## **Notice of Modification**

## Section 4.55(2) of the Environmental Planning and Assessment Act 1979

The Development Consent (DA 165-7-2005) for the Haerses Road Sand Quarry Project granted by the Minister for Planning on 14 February 2006

Figure 1 – Tertiary Sands and Friable Sandstone Extraction Areas

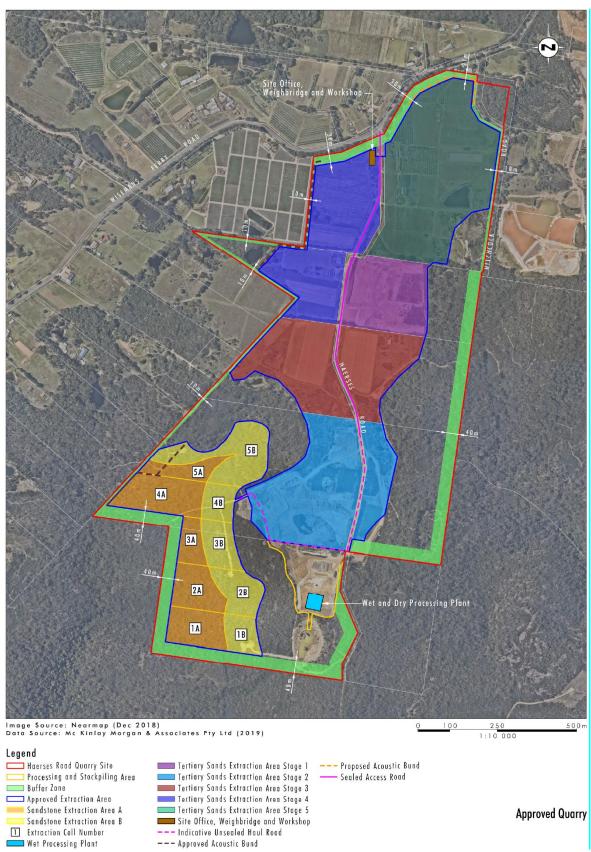
- In the list of definitions:
  - in the definition of Mod 1 Extraction Area, delete the words "the Modification Disturbance Area in Figure 2" and replace with "Sandstone Extraction Area A and Sandstone Extraction Area B in Figure 1";
  - in the definition of MTSGS buffer zone, delete the words "Extraction Area B in Figure 2" and replace with "Sandstone Extraction Area B in Figure 1"; and
  - after the definition for "Mod 1 Extraction Area" insert the following:
  - MR (Mod 3)

**Buffer Zones**

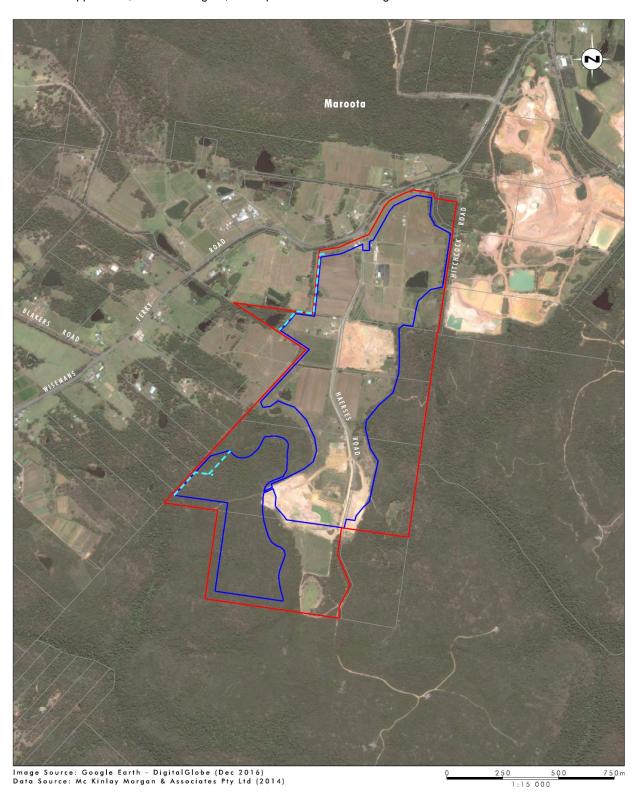
### 16. In Appendix 2, delete the Figure, and replace with the following:

**Acoustic Bunds**

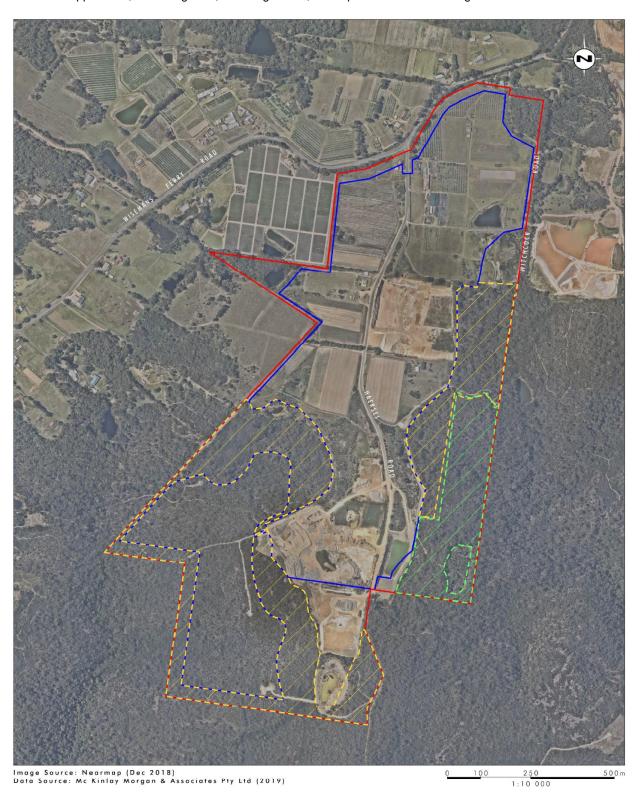
## 17. In Appendix 3, delete the Figure, and replace with the following:

Figure 1- Haerses Road Offset Area

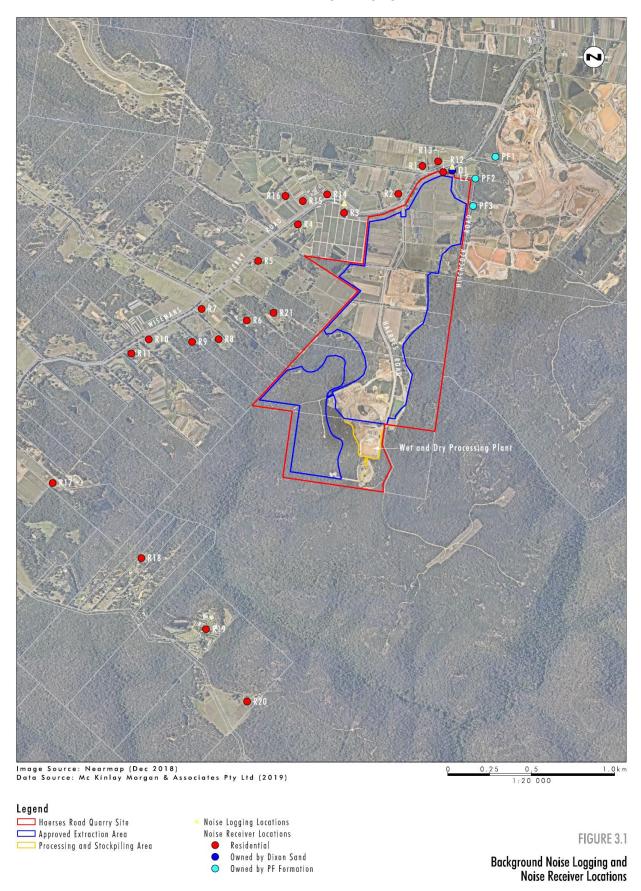
18. In Appendix 4, delete Figure 1, including its title, and replace with the following:
